**Community Development Block Grant Disaster Recovery Program (CDBG-DR)
Owner Occupied Rehabilitation and Rebuilding Program (OORR)**

(#1773) 369 HUBBARD ROAD, HIGGANUM, CT

**Addendum # 01
September 13, 2017**

EXISTING ROOF PLAN
SCALE: 1/8"=1'-0"

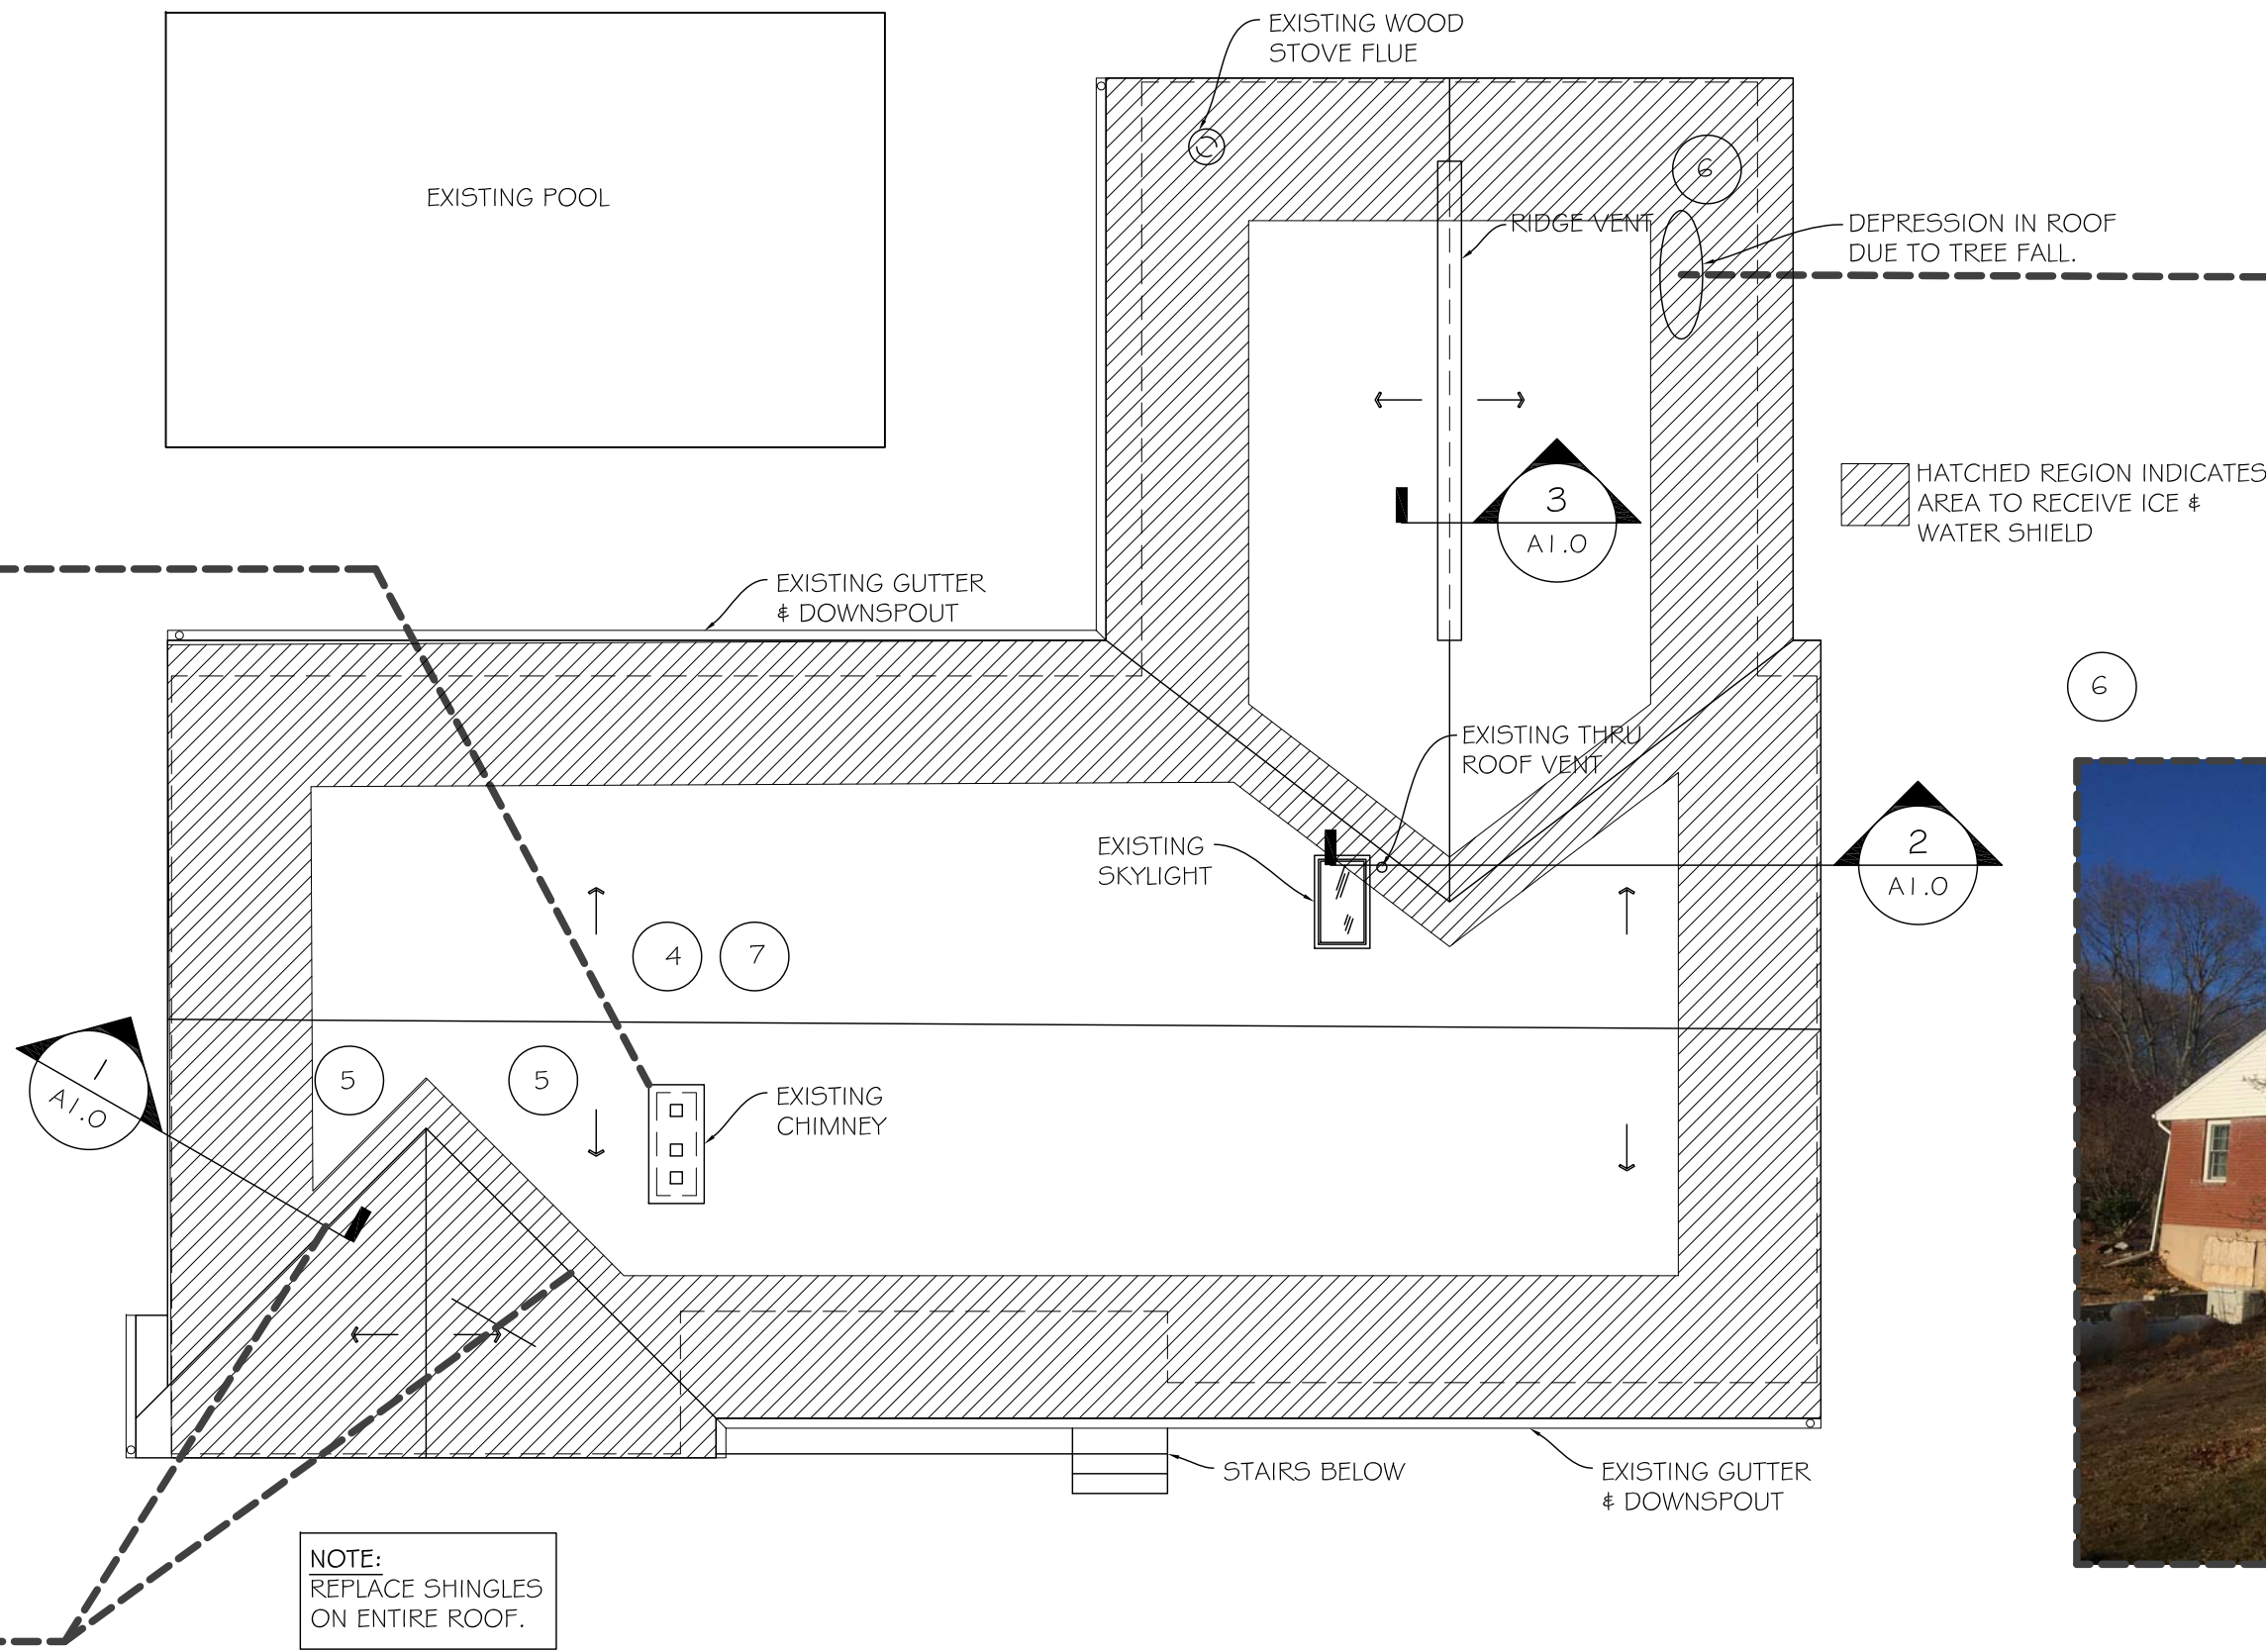
1. All roofing to be removed. (Plywood to be replaced should be identified as a SF Unit Price).
2. Add Gutter and leader at South Side eve of Bonus Room. Reuse all other gutters and downspouts. Provide splash guard – see plans.

EXISTING FLOOR PLAN
SCALE: 1/8"=1'-0"

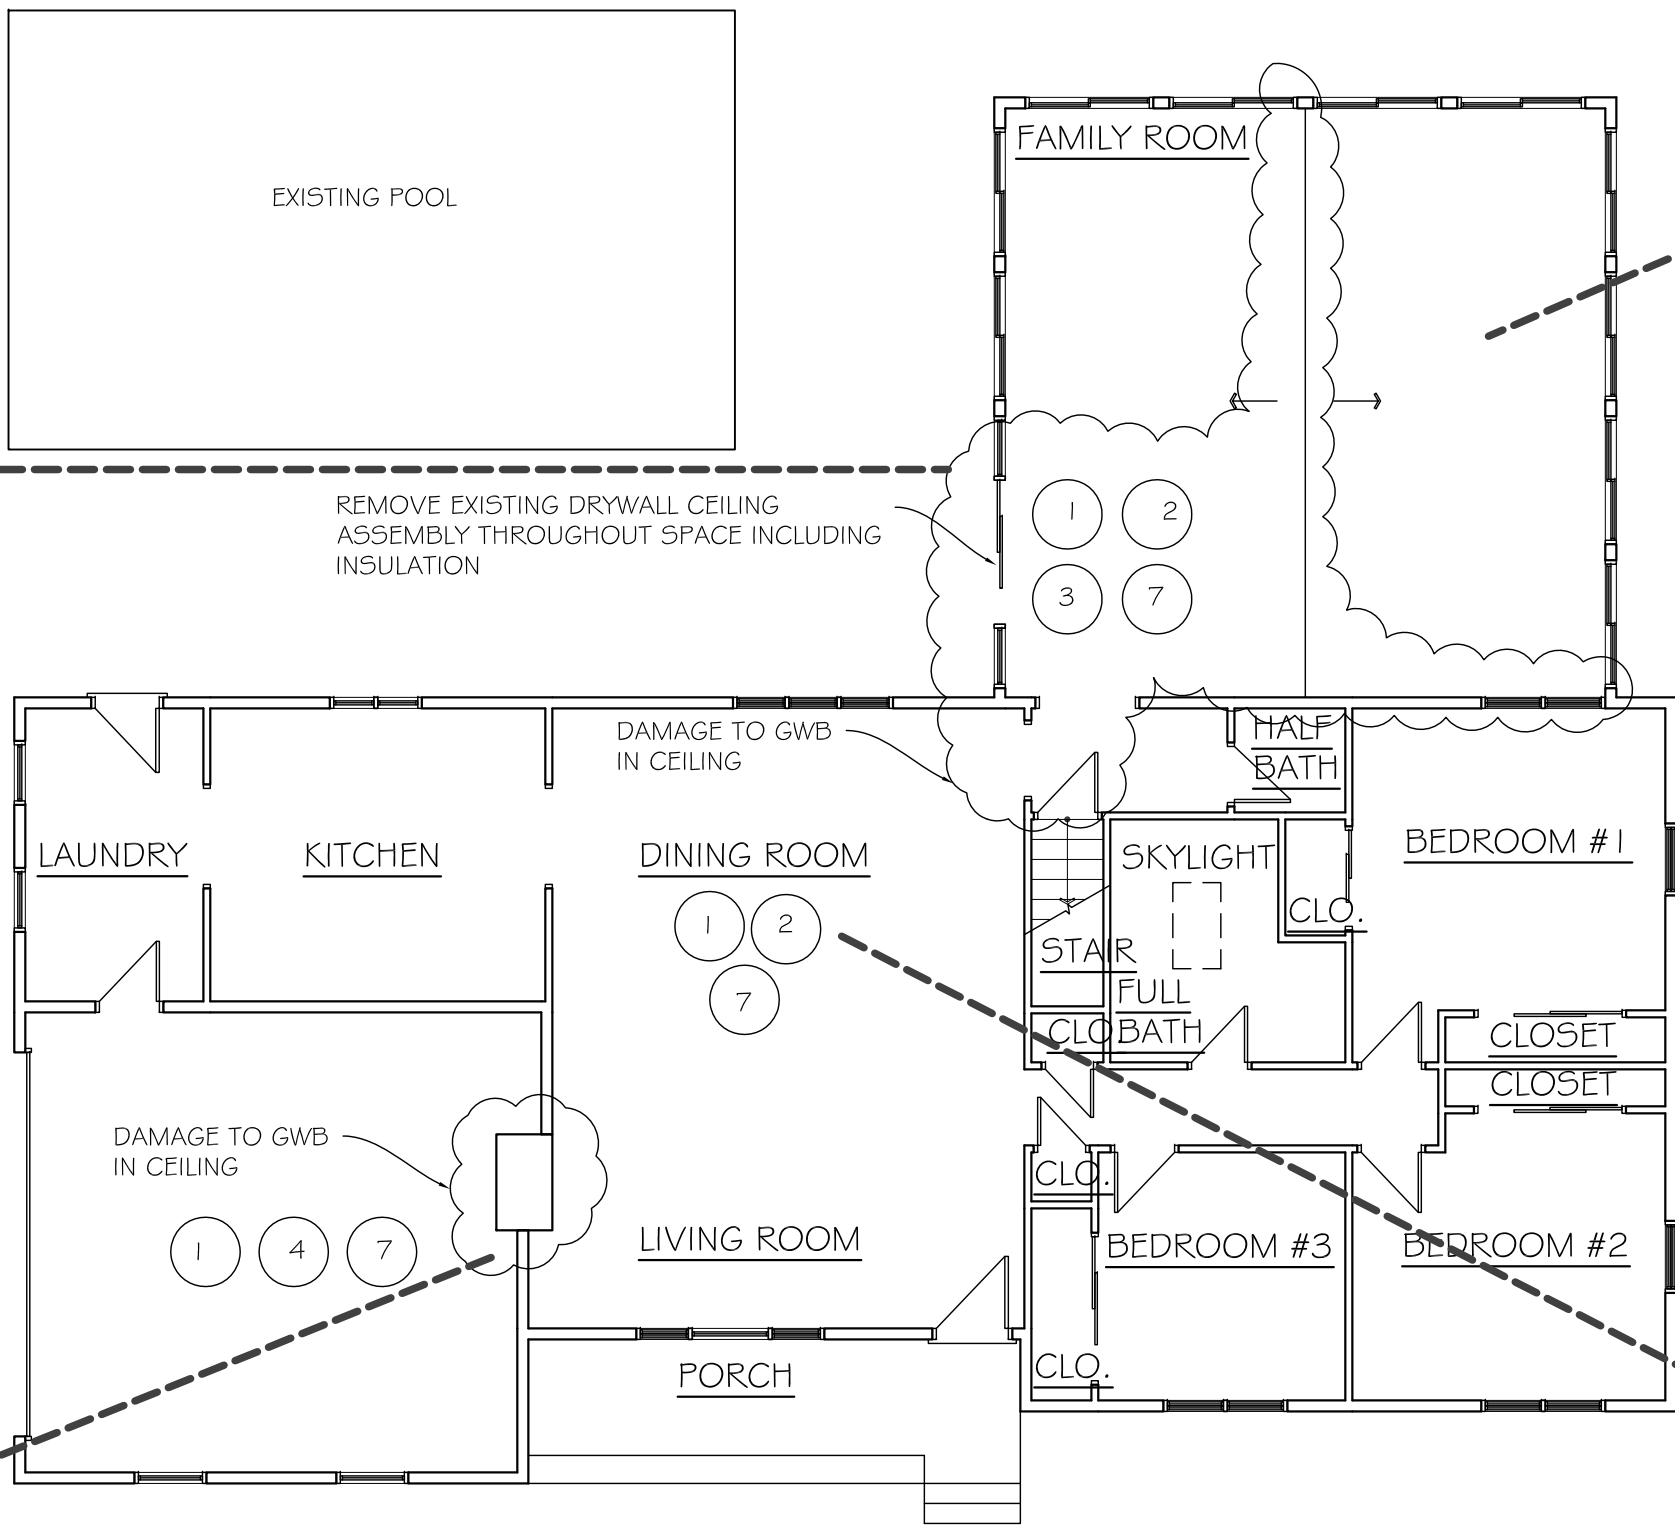
3. Bonus Room entire floor to be and refinished after repairing damaged areas. Note 11' x 11' area for the Hot Tub to remain – see plans.
4. Owner shall empty Bonus Room Furniture. Contractor to remove, store, reinstall Gas Stove.

9. Entire Garage Ceiling shall be painted.
10. Install crown molding in dining room – see plans.
